memorandum

TO Selwyn District Council

FROM Chris Bender

RE Plan Change 82 – Odour Assessment Review

Figure 2 Proposed Plan Change Area 73 with Separation Distances from Odour Generating Activities

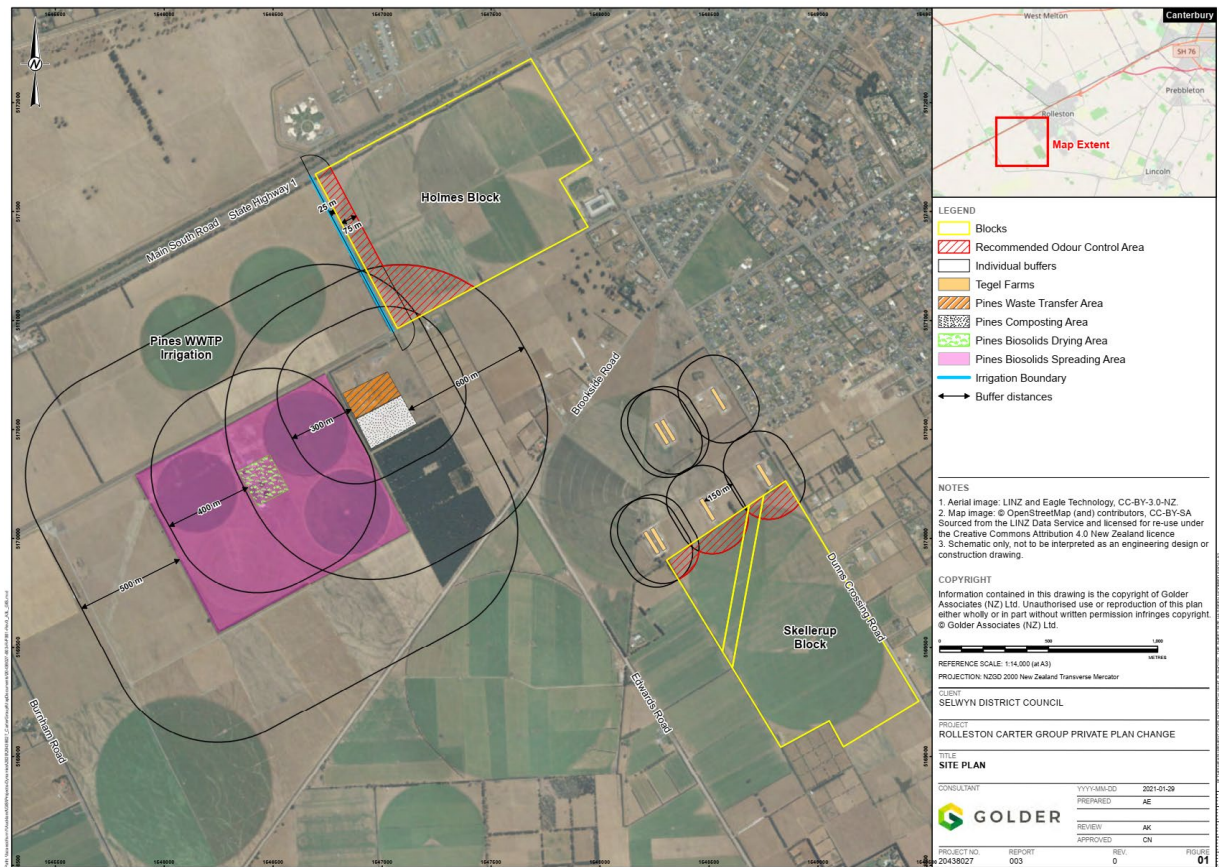
11. Where the buffer zones impinged upon the PC73 plan change areas, these were designated as Odour Control Setback Areas (OCSAs) within which the development of housing will be restricted. The OCSAs relevant to PC73 were determined primarily by the 600 metre setback from the active composting area of the PRRP, which resulted in a setback area within the southwestern corner of the Holmes Block of PC73. The 150 metre setback from the Tegel Poultry Operation sheds resulted in OCSAs of the Skellerup Block of PC73. The Holmes and Skellerup blocks of PC73 together with the OCSAs are shown in Figure 2.
